Access Compliance Report

Public Rights-of-Way

(Curb Ramps)

Intersection ID: 10012605	Main Street: MEADOW_KNOLL_DR	Cross Street: N/A	Location: E
ADA ID: 06FDCBE03DA9	Ramp Type: PerpDiag	Initial Pass/Fail: Fail	Overall Compliance: No
		Severity Score: 8.75

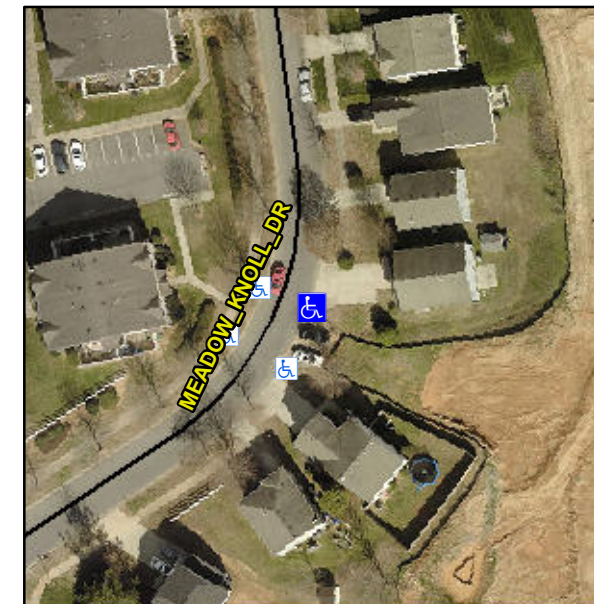
Not Found, R304.5.1

Compliance	Description	Data	Compliance	Description	Data
N/A	Ramp Length (in)	87.0	Yes	Ramp Slope (%)	6.1
No	Ramp Width (in)	46.0	Yes	Ramp XSlope (%)	2.0
N/A	Flare Type LT	N/A	N/A	Flare Type RT	N/A
N/A	Flare Slope LT (%)	N/A	N/A	Flare Slope RT (%)	N/A
N/A	Flare Traversable LT?	N/A	N/A	Flare Traversable RT?	N/A
N/A	Landing Length (in)	N/A	N/A	DWS Provided?	N/A
N/A	Landing Width (in)	N/A	N/A	DWS Contrast?	N/A
N/A	Landing Slope (%)	N/A	N/A	DWS Length (in)	N/A
N/A	Landing X Slope (%)	N/A	N/A	DWS Full Width?	N/A
N/A	Landing Curb? (Y/N)	N/A	N/A	DWS Offset (in)	N/A
N/A	Shared Landing?	N/A			
N/A	Gutter Ponding?	N/A	N/A	Gutter Slope (%)	N/A
N/A	Gutter Lip Ht (in)	N/A	N/A	Gutter X Slope (%)	N/A
N/A	Painted X Walk1?	No	N/A	Painted X Walk2?	No
	X Walk 1 Direction	To NW		X Walk 2 Direction	To SW
N/A	X Walk 1 Width (in)	N/A	N/A	X Walk 2 Width (in)	N/A
	X Walk 1 Slope (%)	2.5		X Walk 2 Slope (%)	3.0
	X Walk 1 X Slope (%)	0.0		X Walk 2 X Slope (%)	0.2

Remove & Replace Curb Ramp With Two New Directional Ramps or Equivalent.
